**DC-9****SERVICE BULLETIN****REVISION TRANSMITTAL SHEET**

BULLETIN 24-76

ELECTRICAL POWER - General - Revise Routing and Clamping for Lavatory Pump-to-Timer Wire Assembly.

Revision 1 August 16/85

FIGURE 1 (SHEET 2 OF 6)

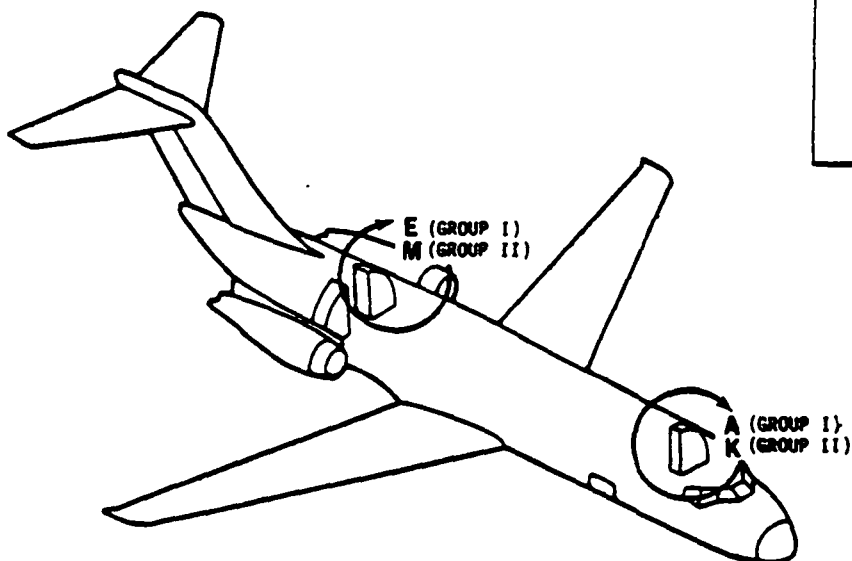
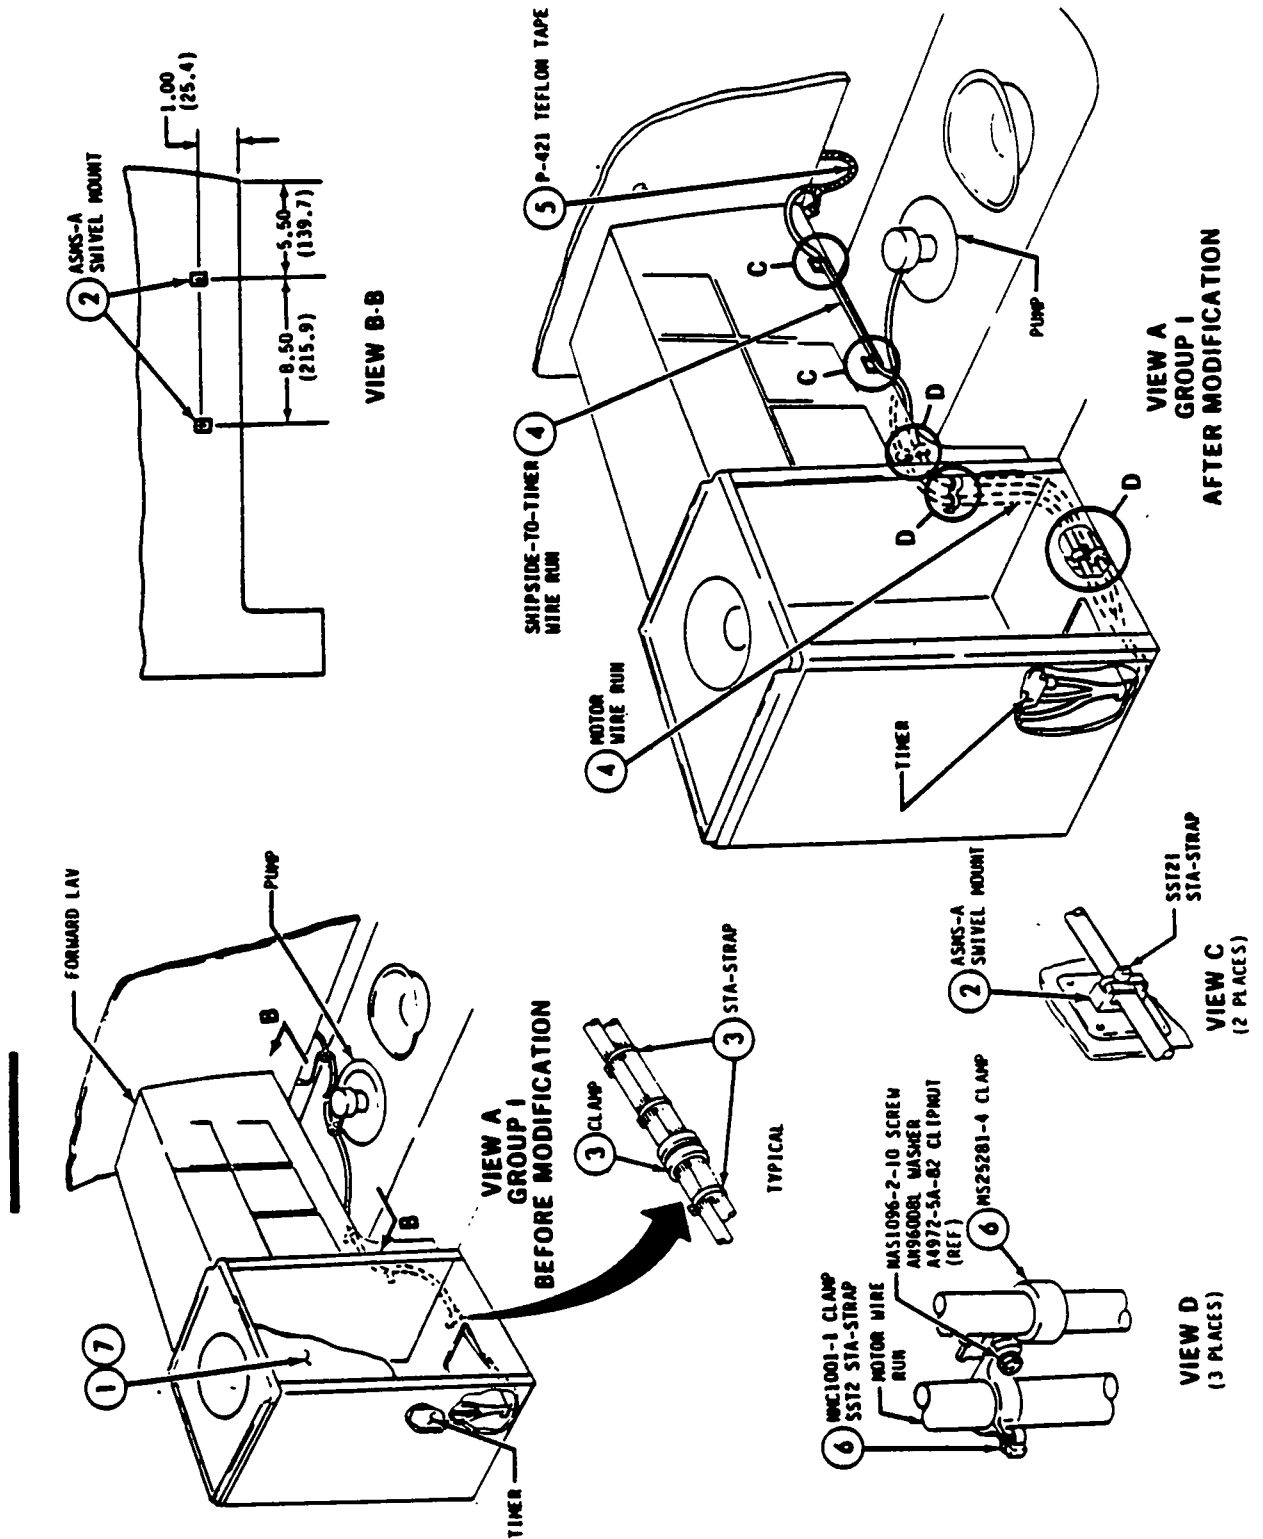
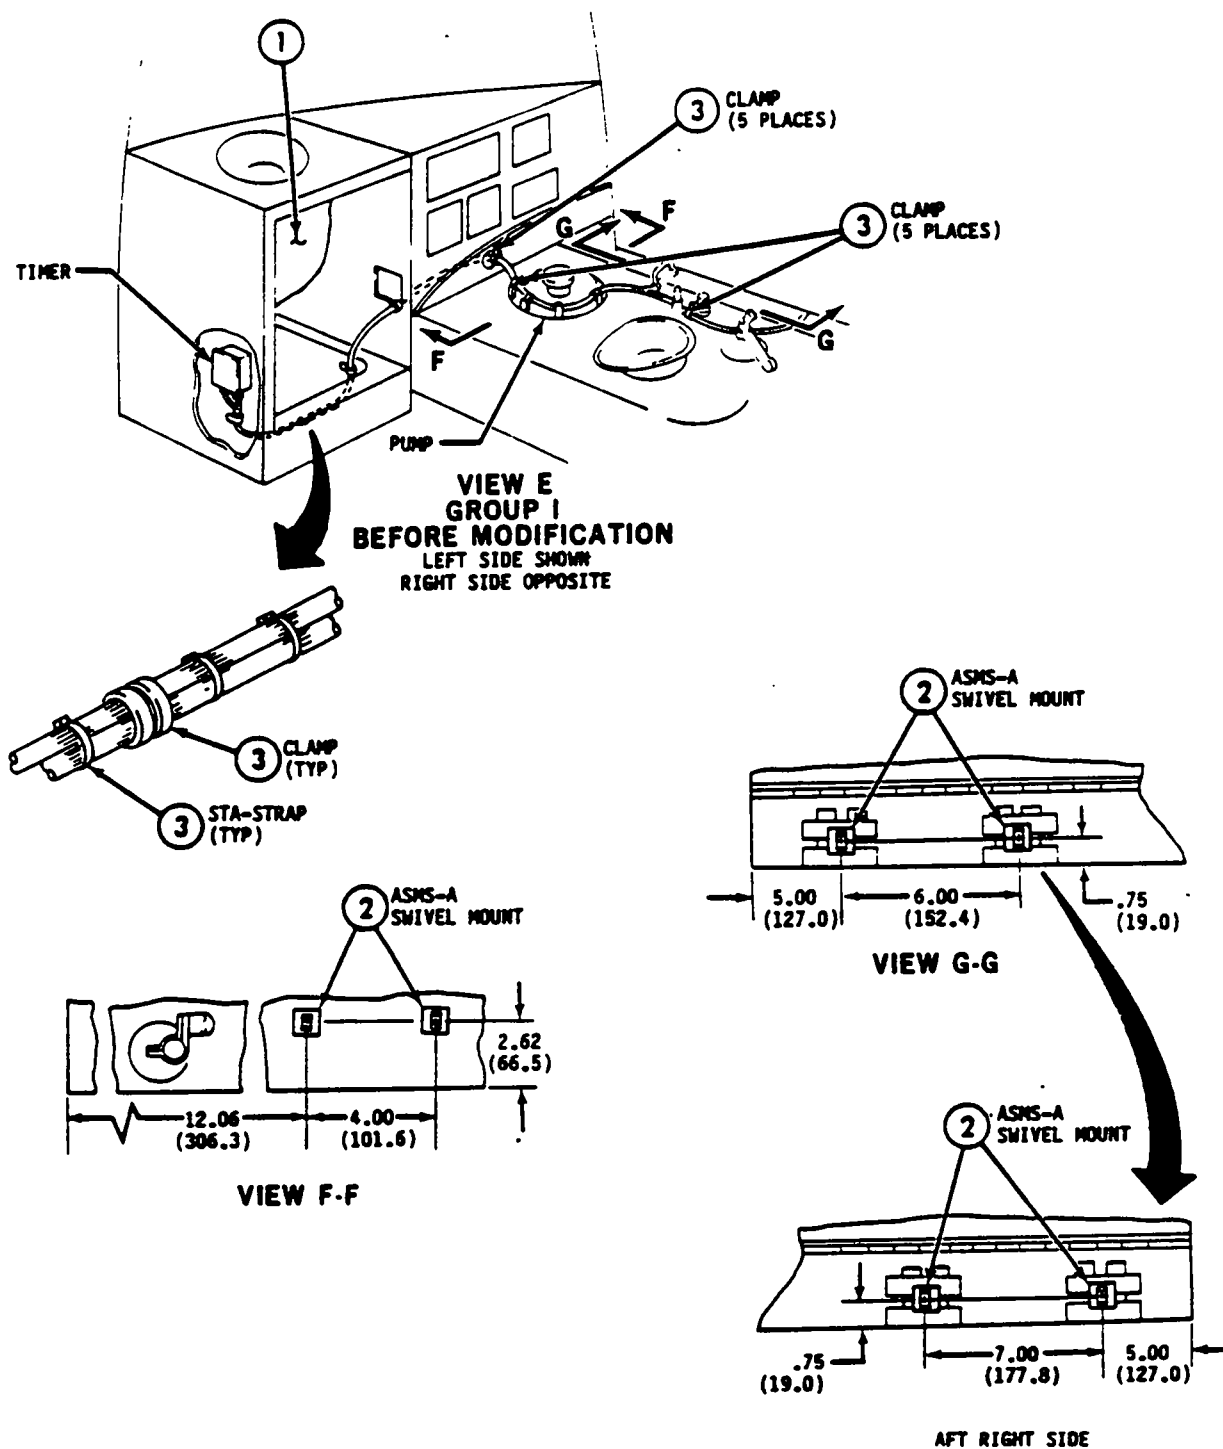
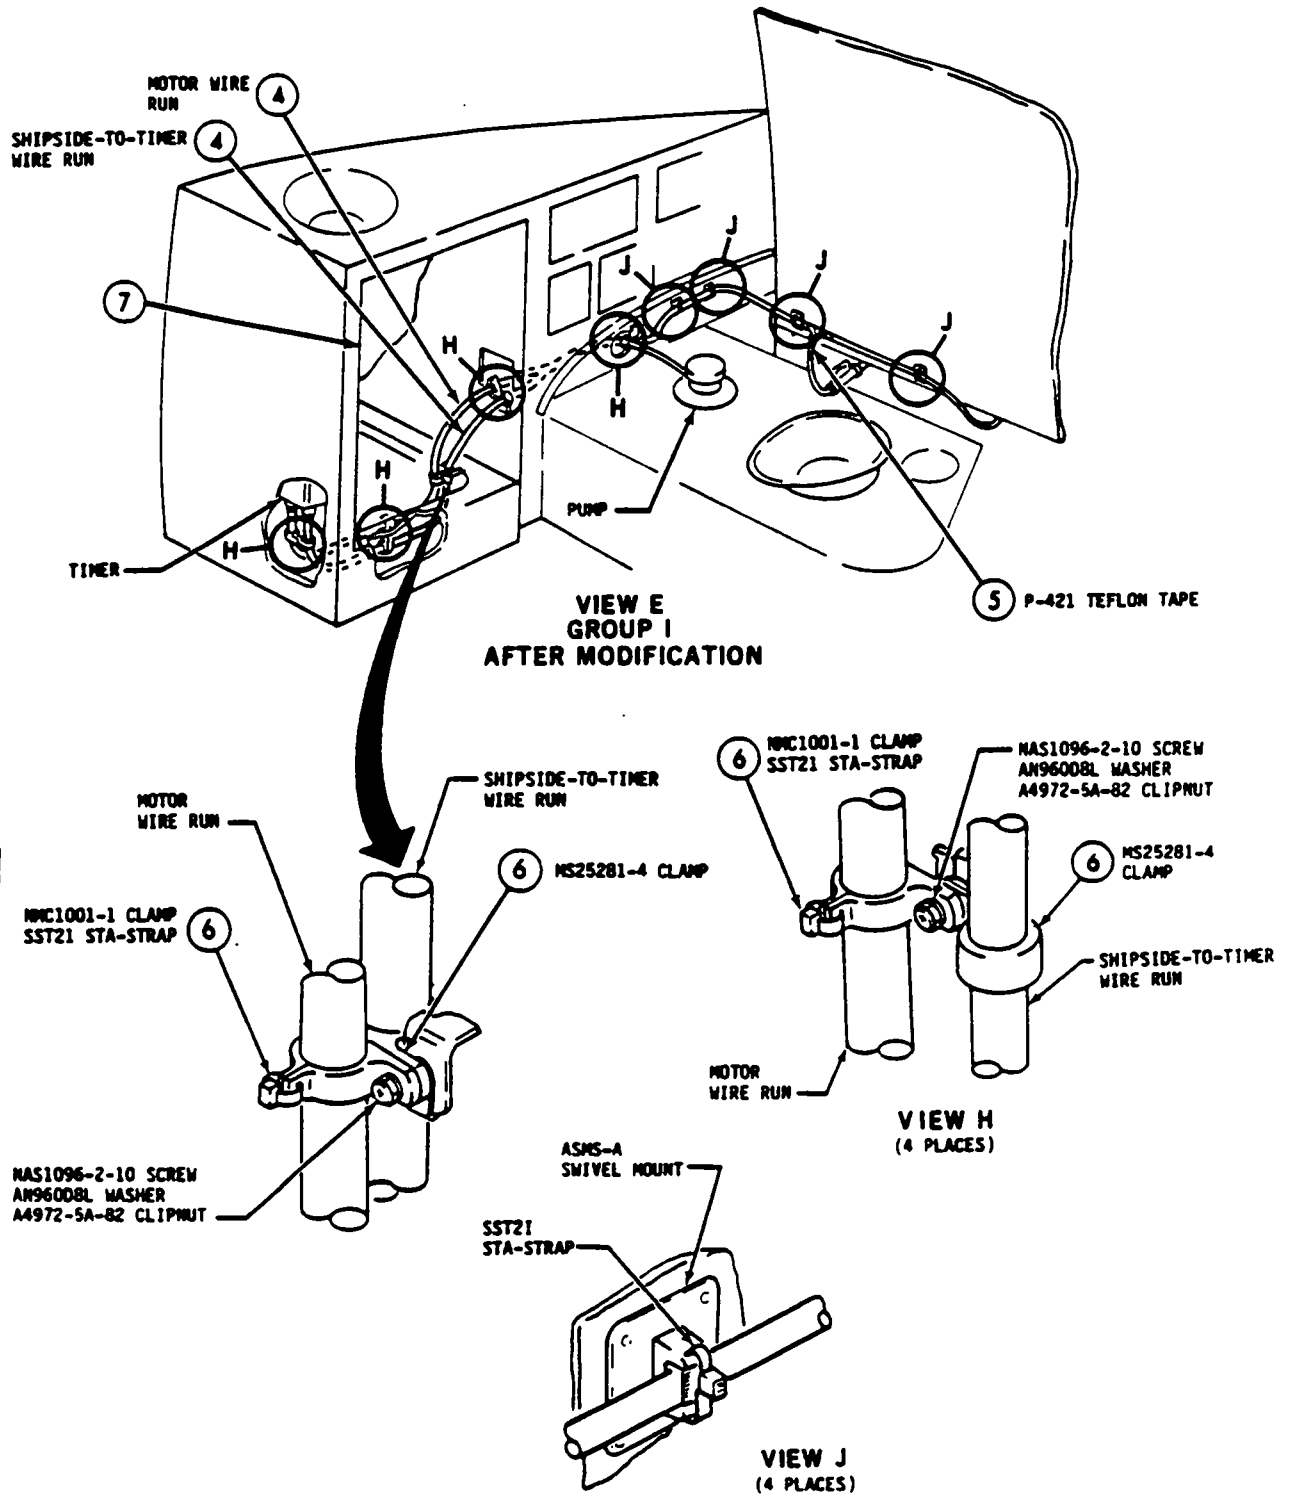
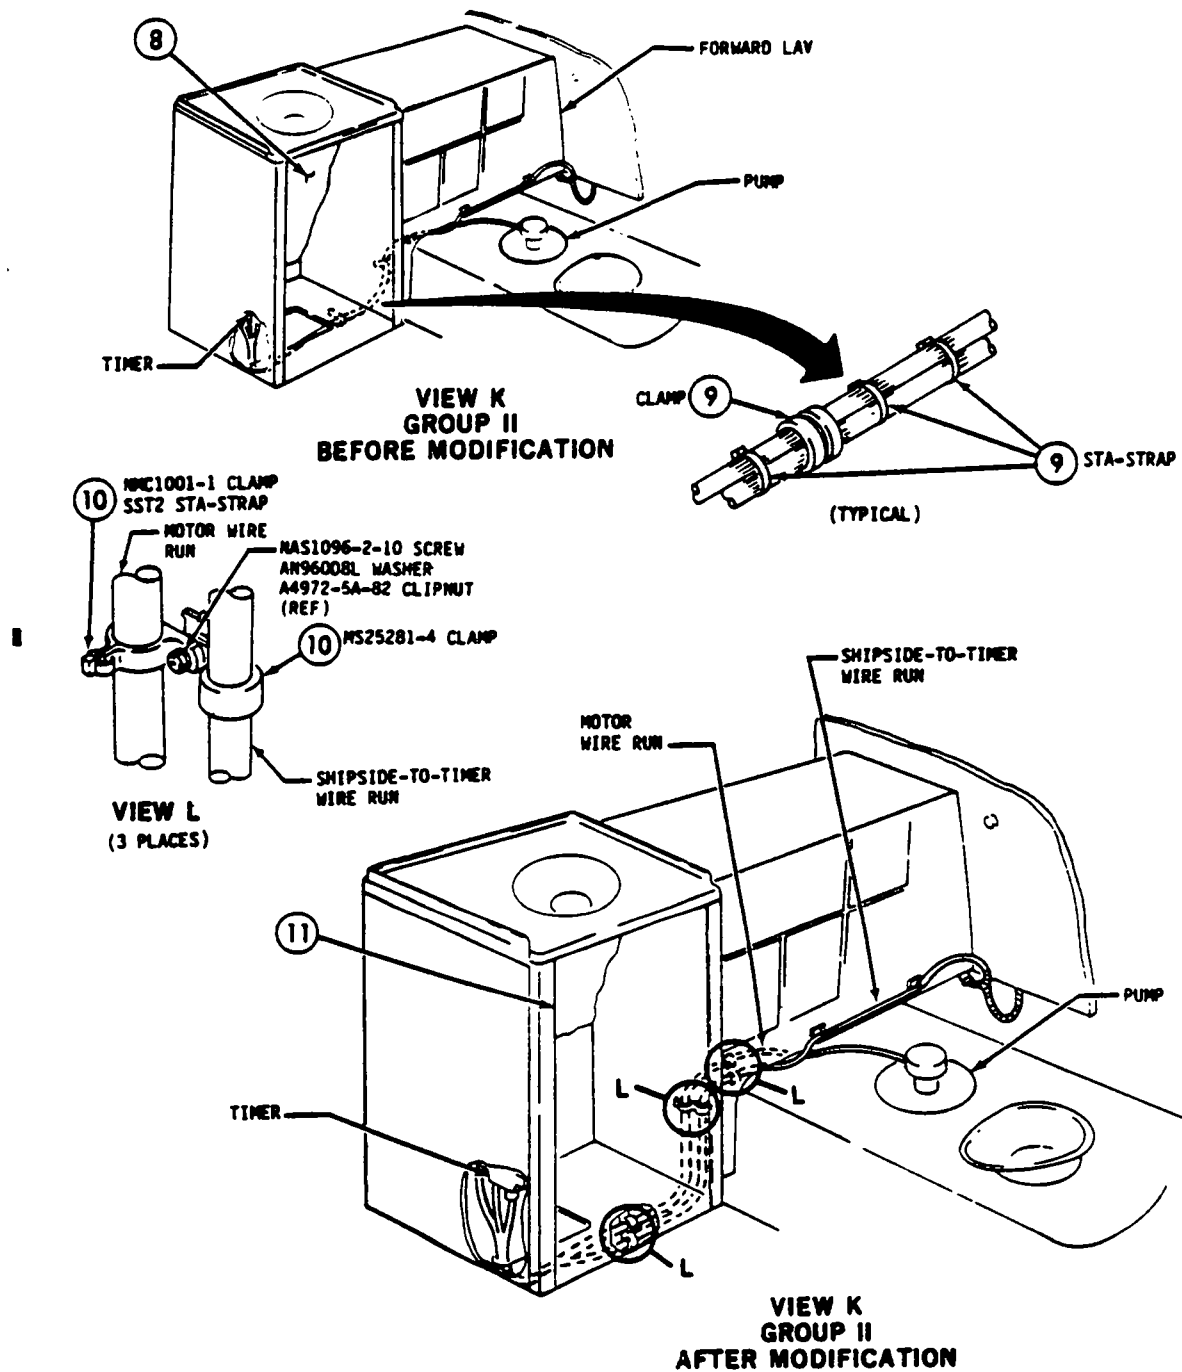
Pages 13, 14, 16, thru 19, 21, 22: Added Note to Figure 1, steps 6 and 10, and Figure 2, Step 3.
Change part number and illustration of clamp on the shipside-to-timer wire run to MS25281-4, was NMC1001-1.

- ① OPEN WASHSTAND DOOR.
- ② INSTALL ASMS-A SWIVEL MOUNTS USING 501 ADHESIVE WITH 501A ACCELERATOR.
- ③ REMOVE EXISTING SST2I STA-STRAPS AND CLAMPS FROM WIRE BUNDLE TO SEPARATE LAVATORY PUMP-TO-TIMER WIRE ASSEMBLY FROM OTHER WIRES.
- ④ RELOCATE SEPARATED WIRE RUNS AS SHOWN.

- ⑤ INSTALL PERMACEL P-421 TEFLON TAPE ON WIRING EXTENDING INTO CONDUIT.
- ⑥ REVISE CLAMPING AS SHOWN USING NEW AND EXISTING ATTACHING PARTS.

- ⑧ OPEN WASHSTAND DOOR.
- ⑨ REMOVE EXISTING SST2I STA-STRAPS AND CLAMPS FROM WIRE BUNDLE TO SEPARATE LAVATORY PUMP-TO-TIMER WIRE ASSEMBLY FROM OTHER WIRES.
- ⑩ REVISE CLAMPING AS SHOWN USING NEW AND EXISTING ATTACHING PARTS.

NOTE: IT IS PERMISSIBLE TO USE LARGER OR SMALLER CLAMPS TO ENSURE A PROPER FIT.

NOTE: IT IS PERMISSIBLE TO USE LARGER OR SMALLER CLAMPS TO ENSURE A PROPER FIT.
